**Part #: RR-1320 Anti-Spatter Reservoir for TOUGH GUN™ Reamers**

You may have expected a slightly different reservoir than the one found in this package. Recently, we made a few improvements to the design of this product:

**Figure 1** – The improved RR-1320 anti-spatter reservoir is now made of Nylon and has a slight yellow hue when compared to the original Polycarbonate material.

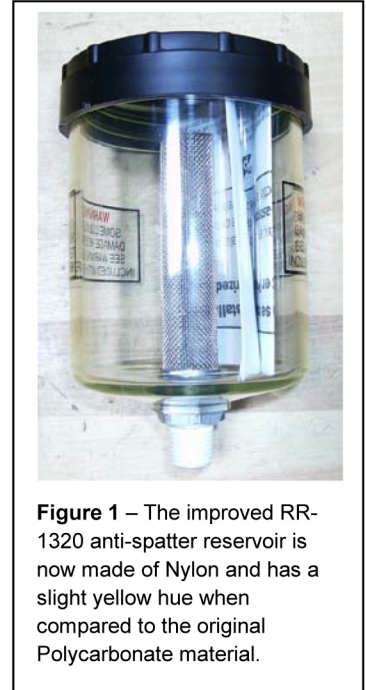
- The reservoir is now made of Nylon rather than Polycarbonate (*see Figure 1*)
  - The Nylon material has proven to be more durable over time when compared with Polycarbonate.
  - Please note that the Nylon material has a slight yellow appearance when compared to the clear Polycarbonate.
- The top cap has been simplified (*see Figure 2*)
  - The previous design featured several valves for filling and venting the reservoir. These valves also allowed debris to collect in the reservoir.
  - The new design does not have any exposed valves on the top of the cap and is vented through the threads to prevent a vacuum seal.
